MODIFICA INFOCENTER ALFA 156

INFOCENTER ALFA 156 IMPROVEMENT

AUTORADIO/NAVIGATORE ALFA 147

ALFA 147 RADIO/NAVIGATOR IMPROVEMENT

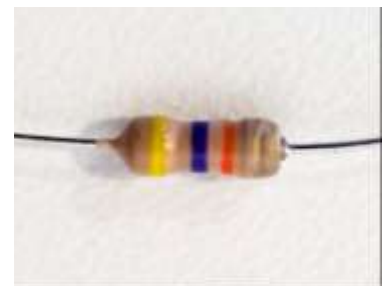
La resistenza (47K OHM 1/8W) in figura sottostante va inserita qualora il display fosse poco luminoso.

The resistor in the picture (47K OHM 1/8W) must be inserted if the display isn't bright enough.

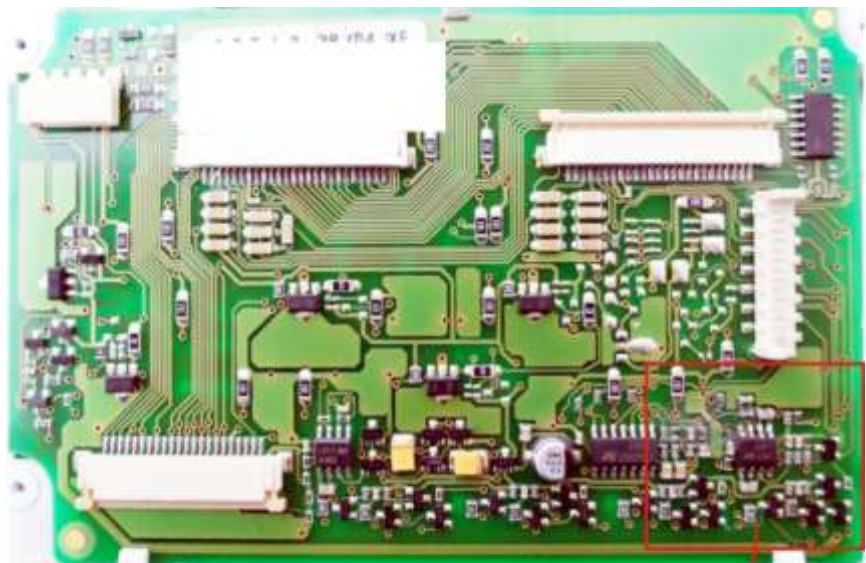
La resistenza (12K OHM 1/8W) in figura sottostante va inserita qualora il display fosse poco luminoso.

The resistor in the picture (12K OHM 1/8W) must be inserted if the display isn't bright enough.
